# AUTOELECTRO

## STARTER MOTORS & ALTERNATORS

**IMPORTANT PLEASE READ THE INFORMATION BELOW BEFORE FITTING THIS PART AS THERE ARE KNOWN ISSUES WHICH WILL RESULT IN THE PREMATURE FAILURE OF THE UNIT AND MAY INVALIDATE YOUR WARRANTY**

ORIGINAL BELT ROUTING

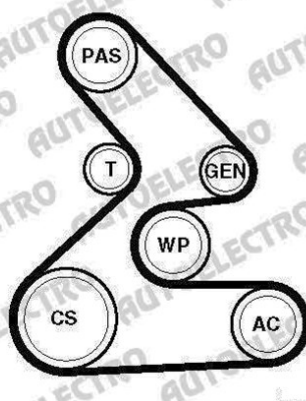
The vehicle to which this alternator is fitted has a known fault which results in the premature failure of the clutch pulley and/or bearings. The premature failure can be caused due to excessive load being exerted to the alternator pulley and bearings.

It is recommended that the belt is replaced with a **7PK1785** and a guide pulley is removed. By carrying out this modification the pressure applied to the components is reduced.
